CITY OF ALBUQUERQUE

RE: Precision Eye Center
7521 Alameda Blvd. NE
Grading & Drainage Plans
Engineer's Stamp Date: 02/28/23
Hydrology File: C19D070

Based upon the information provided in your submittal received 03/02/2023, the Grading & Drainage Plans **are not** approved for Building Permit, Grading Permit and SO19 Permit. The following comments need to be addressed for approval of the above referenced project:

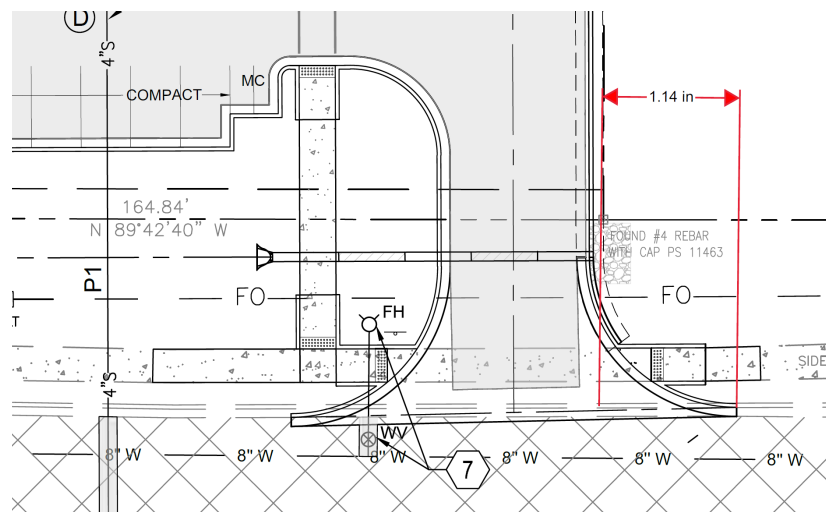
2. The project curb returns cannot extend beyond the property line. The curb return must become tangent at or before the property line, so please move the entrance about 23 ft to the west. Also, please make the other curb return tangent to the existing curb because it is currently not buildable as shown.

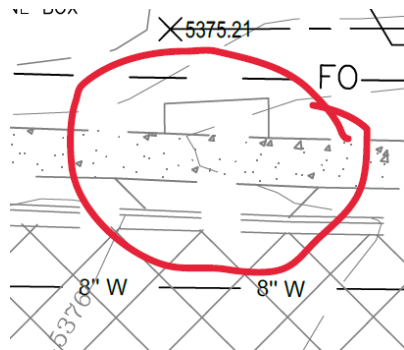
- The existing drive pad at the southwest corner of the property needs to be called out as "Remove existing drive pad and replace with curb & gutter and sidewalk."

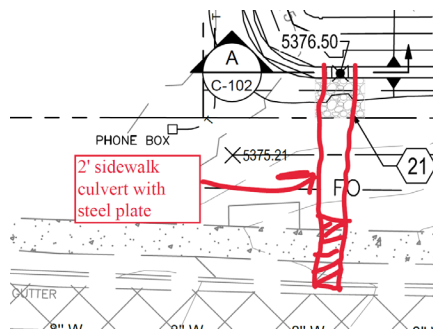
- Please note that any existing remanence of a natural arroyo is just what is left over from when La Cueva Arroyo was placed in a concrete channel, so when the adjacent lot is developed, it will be discharging into Alameda which is reflected in the above NAA Master Drainage Plan. Therefore, accommodating for this is not needed, but any existing flows can be just handled with a curb cut in the curb return to allow the flows to go into Alameda Blvd. So, the curvet that shown does not need to be installed and the grades for the drive needs to follow CoA Detail 2426 with a water block.

C-102

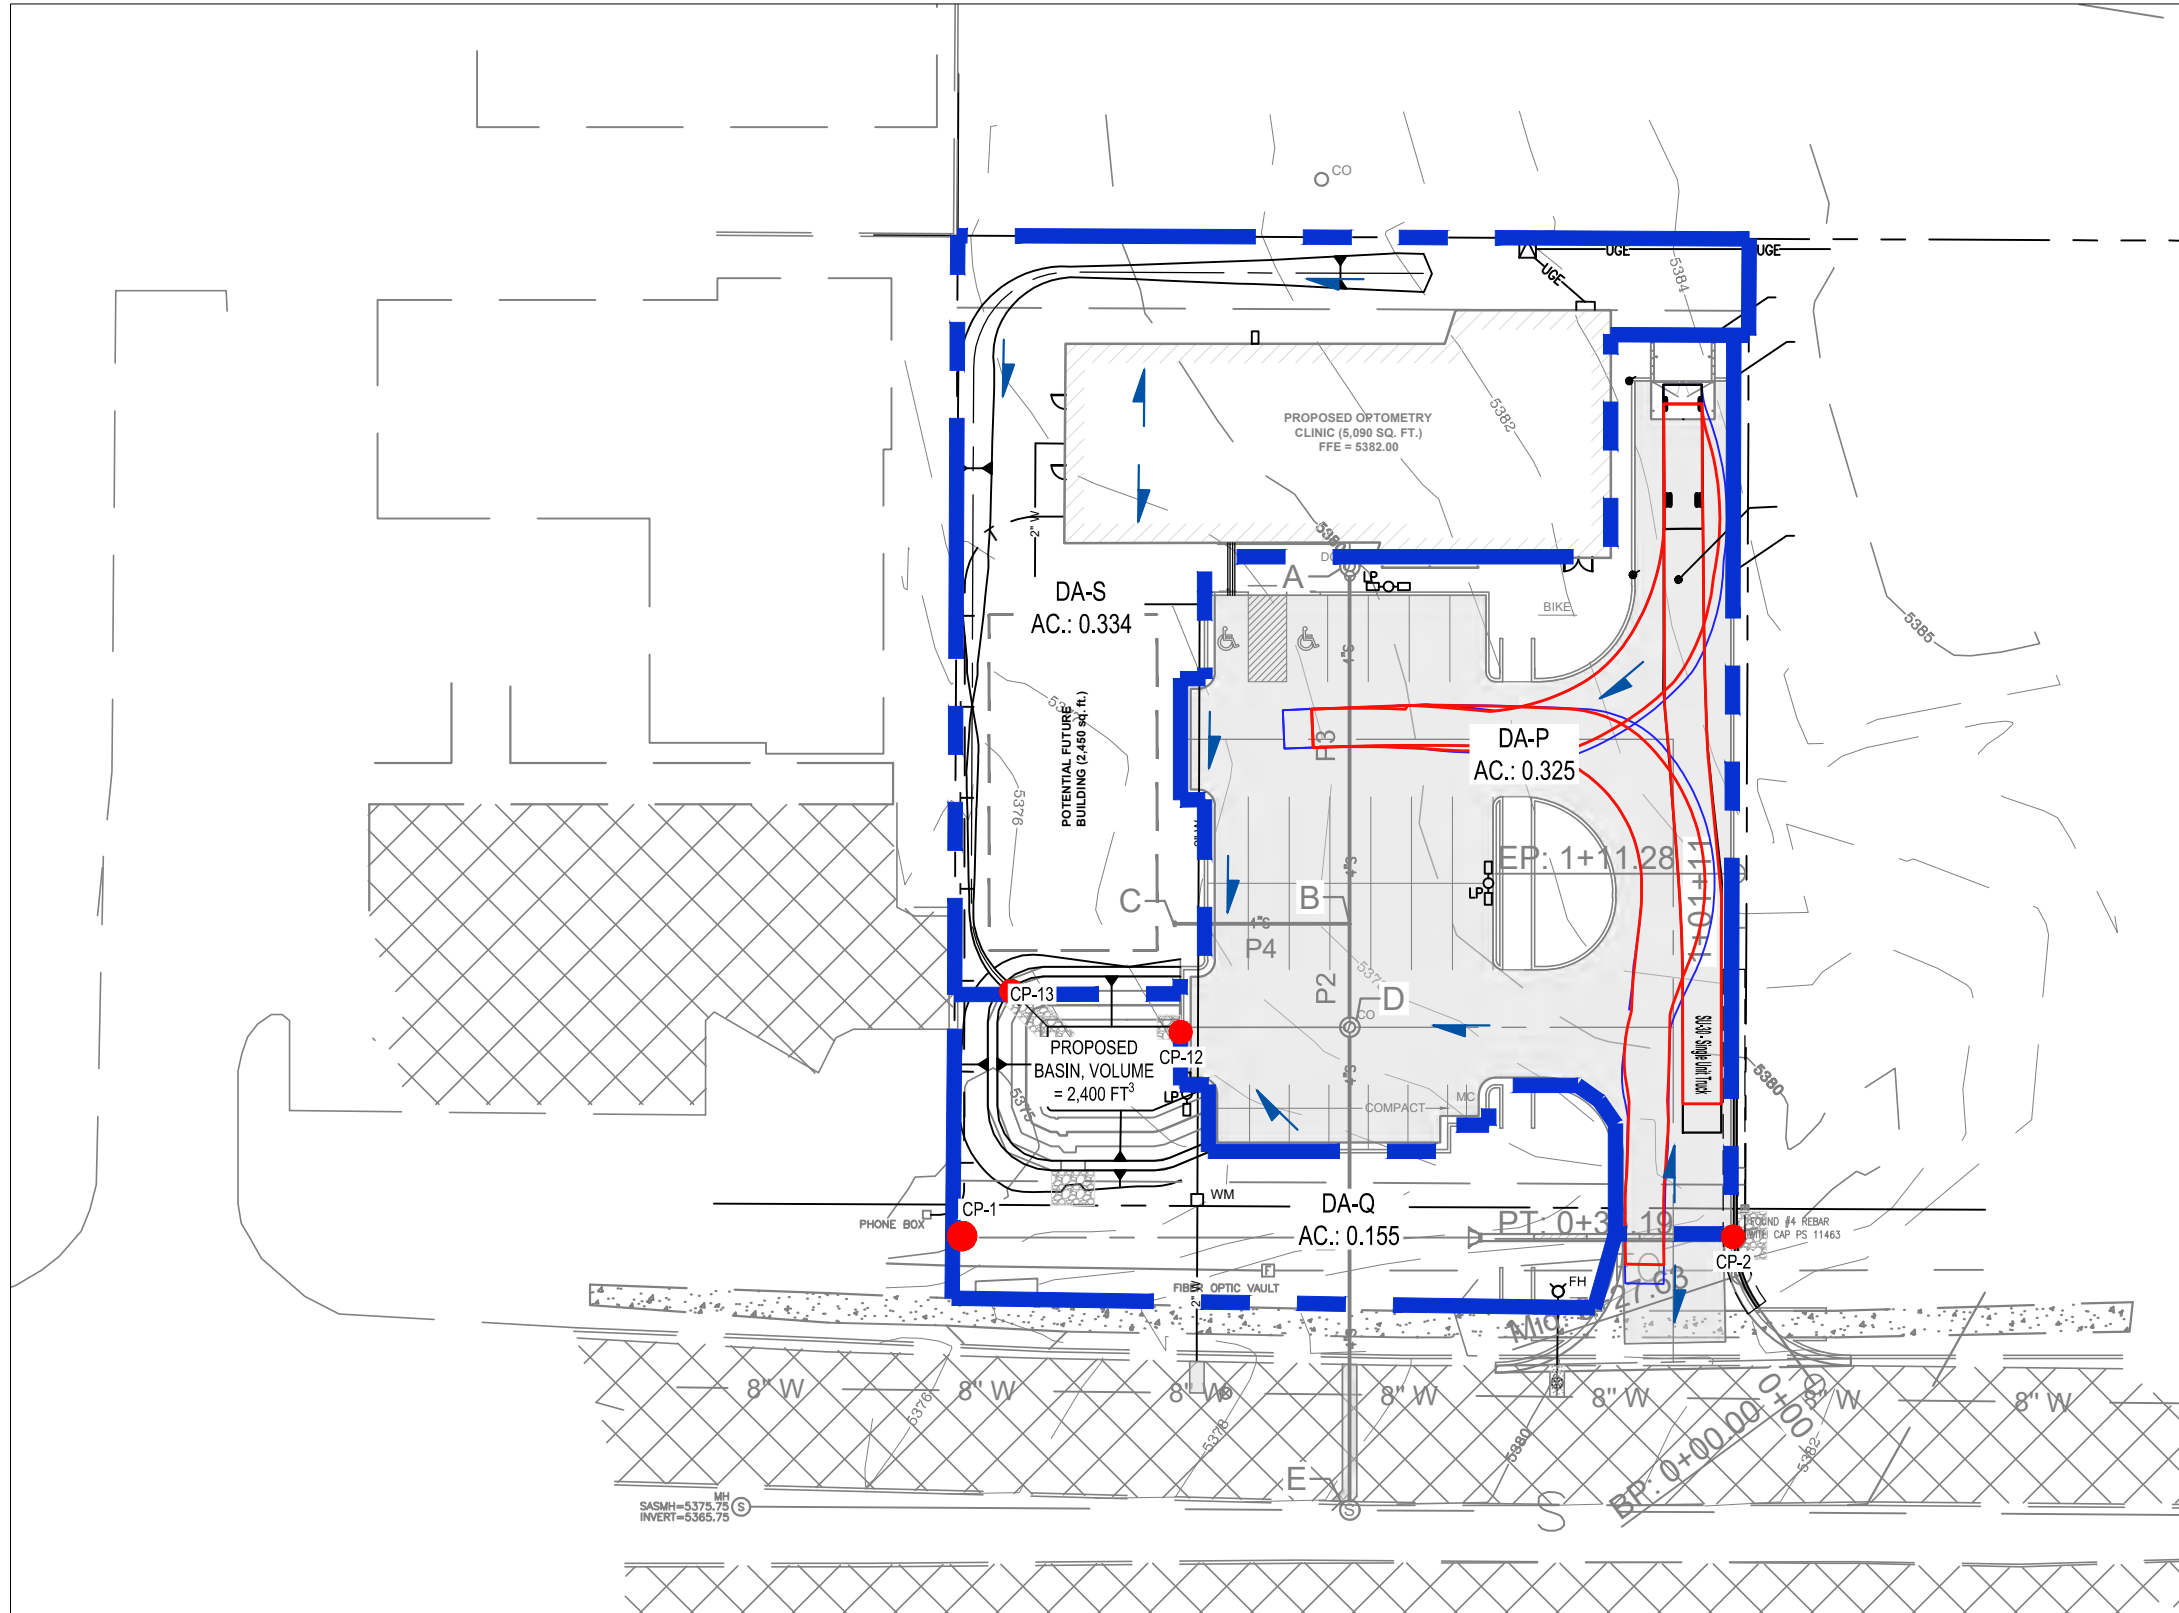
- On Sheet 102, please provide a sidewalk culvert for the spillway for the stormwater quality pond to Alameda Blvd. and label per CoA Detail 2236. Please also show the invert at the pond (this is the SWQ water surface elevation) and the invert at the existing gutter on Alameda Blvd.
